Access Compliance Report

Public Rights-of-Way

(Curb Ramps)

Intersection ID: 47646	Main Street: ALDWYCH_WY	Cross Street: DESHLER_MORRIS_LN	Location: SW
ADA ID: 9CEAF8515A6E	Ramp Type: PerpDiag	Initial Pass/Fail: Fail	Overall Compliance: No
Severity Score: 22.5			
Codes/Mitigation Info/Possible Solution		Field Measurements/Component Compliance

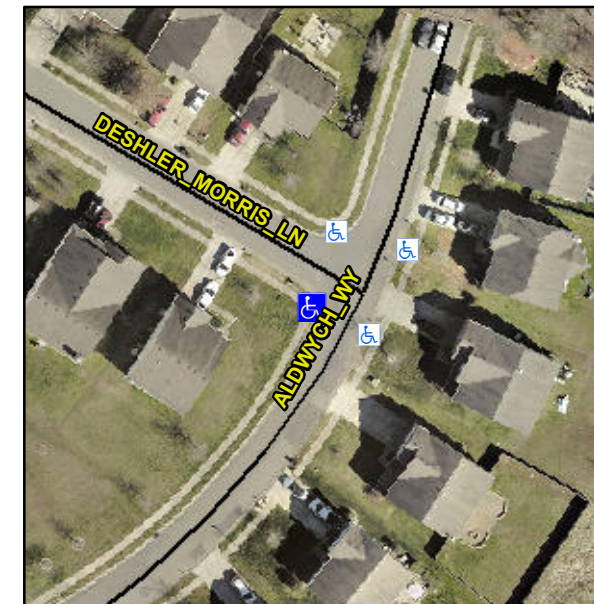
Not Found, R304.5.1, R304.2.2, R304.5.3

Compliance	Description	Data	Compliance	Description	Data
N/A	Ramp Length (in)	47.0	No	Ramp Slope (%)	11.4
No	Ramp Width (in)	46.5	No	Ramp XSlope (%)	2.8
N/A	Flare Type LT	N/A	N/A	Flare Type RT	N/A
N/A	Flare Slope LT (%)	N/A	N/A	Flare Slope RT (%)	N/A
N/A	Flare Traversable LT?	N/A	N/A	Flare Traversable RT?	N/A
N/A	Landing Length (in)	N/A	N/A	DWS Provided?	N/A
N/A	Landing Width (in)	N/A	N/A	DWS Contrast?	N/A
N/A	Landing Slope (%)	N/A	N/A	DWS Length (in)	N/A
N/A	Landing X Slope (%)	N/A	N/A	DWS Full Width?	N/A
N/A	Landing Curb? (Y/N)	N/A	N/A	DWS Offset (in)	N/A
N/A	Shared Landing?	N/A			
N/A	Gutter Ponding?	N/A	N/A	Gutter Slope (%)	N/A
N/A	Gutter Lip Ht (in)	N/A	N/A	Gutter X Slope (%)	N/A
N/A	Painted X Walk1?	No	N/A	Painted X Walk2?	No
	X Walk 1 Direction	To SE		X Walk 2 Direction	To NE
N/A	X Walk 1 Width (in)	N/A	N/A	X Walk 2 Width (in)	N/A
	X Walk 1 Slope (%)	0.5		X Walk 2 Slope (%)	4.6
	X Walk 1 X Slope (%)	3.8		X Walk 2 X Slope (%)	0.5

Remove & Replace Curb Ramp With Two New Directional Ramps or Equivalent.
